PLANNING AND DEVELOPMENT SERVICES STAFF REPORT

For Planning Commission Meeting of August 5, 2015

**SUBJECT: Racquet Club of Ann Arbor Public Sidewalk Waiver
(3010 Hickory Lane)**

RACQUET CLUB OF ANN ARBOR
 SITE PLAN
 SIDEWALK OPTION

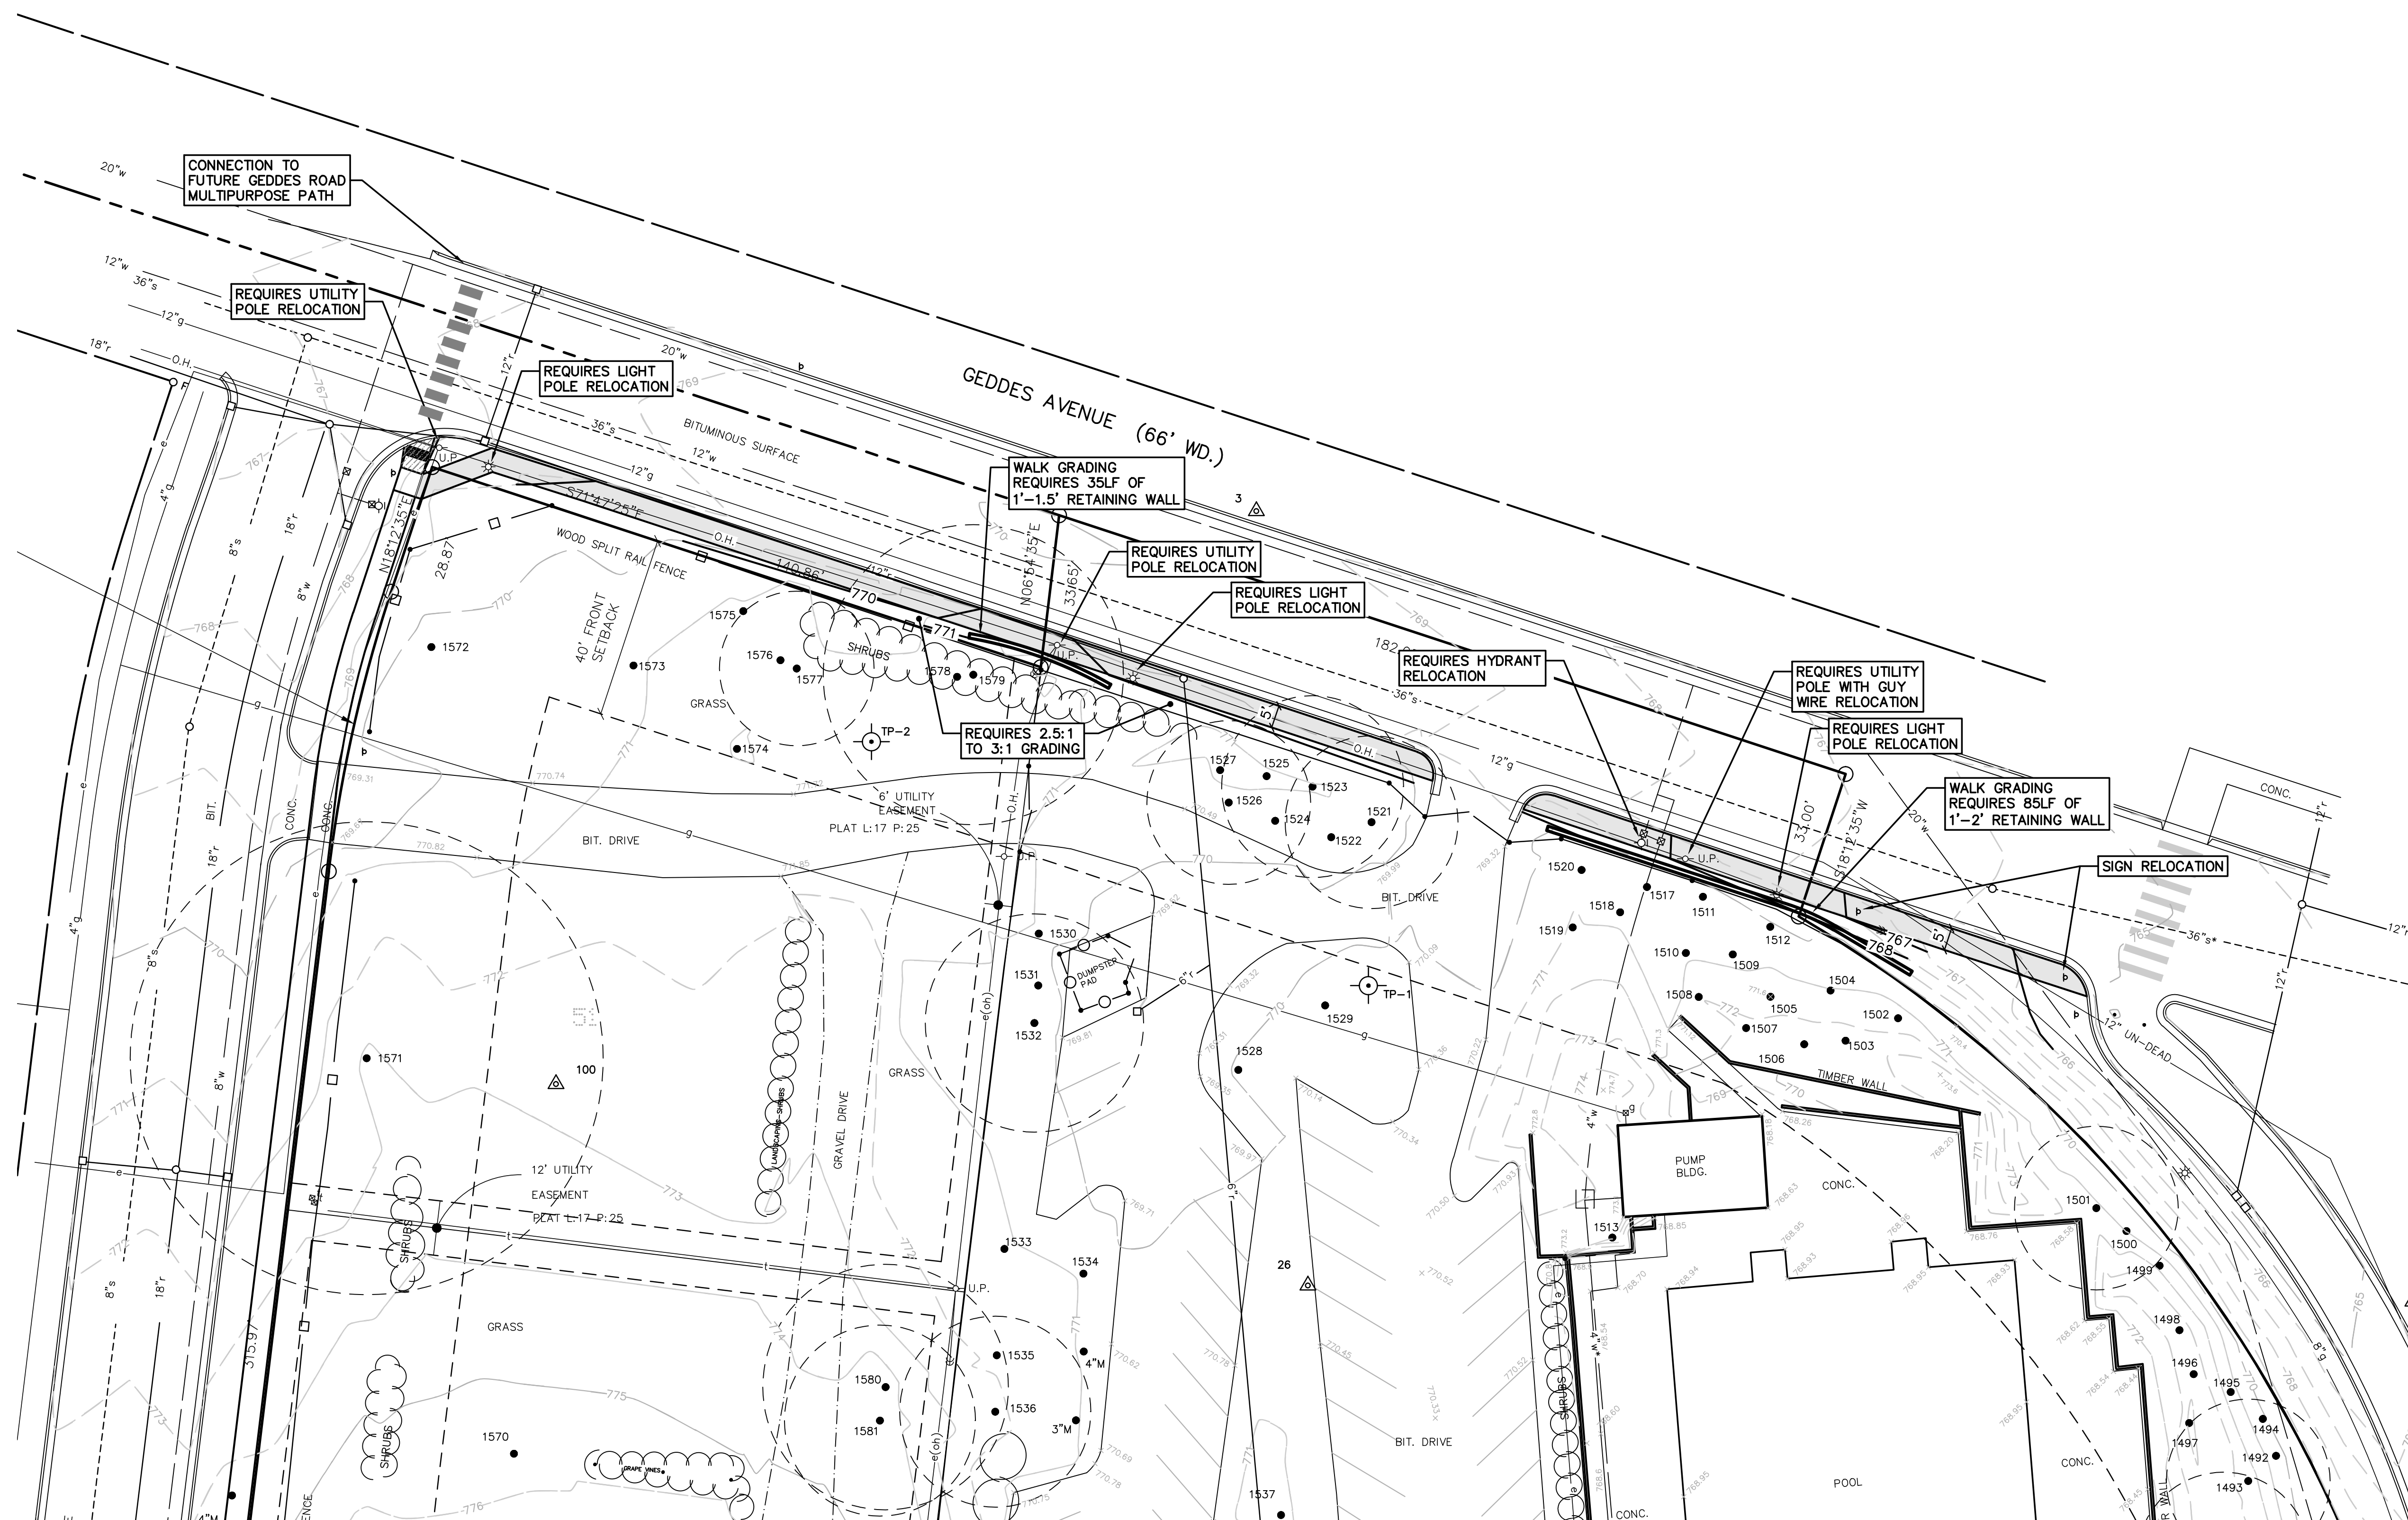
At the time this staff report was written, the petitioner was preparing a cost analysis for constructing a segment of sidewalk in the Geddes Avenue right-of-way. This proposed sidewalk would likely require retaining walls, utility and light pole relocations, and a fire hydrant relocation. The petitioner is also exploring whether a reduced 4-foot wide sidewalk between the existing utility poles and the property line could be accomplished. It is anticipated additional cost analysis and an alternative sidewalk location layout will be available for the August 5th meeting.

The City's roadway consultant on the Geddes Avenue Improvement project, HRC, has looked at the petitioner's Geddes sidewalk concept drawings and associated costs and determined that the projected costs are within the range expected for this alignment. The petitioner's engineer is also exploring whether a narrower sidewalk can be placed within the right-of-way. These findings will be presented, if completed, at the August 5th Planning Commission meeting.

Staff also requested the petitioner show a sidewalk concept on their private property, leaving the existing utilities untouched, as an alternative connection to the Huron Parkway walkway. The petitioner has indicated this alternate path impacts 3-4 landmark trees and 10-14 non-

Staff recommends that the requested waiver from the installation of public sidewalk along Geddes Avenue be **supported**. Based on detailed information provided by the petitioner's engineer, staff concurs that the constraints of slope, utility poles and a fire hydrant make the costs of sidewalk installation excessively disproportionate to the probable use of this segment of sidewalk.

The petitioner provided the dimensions available between the 2 utility poles, 3 light poles and a fire hydrant located on south side of Geddes Avenue and the Racquet Club fence on the north property line. Based on this information, staff determined that this alternative sidewalk would range in width from 2.5 feet to 5.2 feet within the right-of-way. The petitioner declined to provide a sidewalk concept that would encroach on private property, due the location of a stand of mature and landmark trees along the north property line.
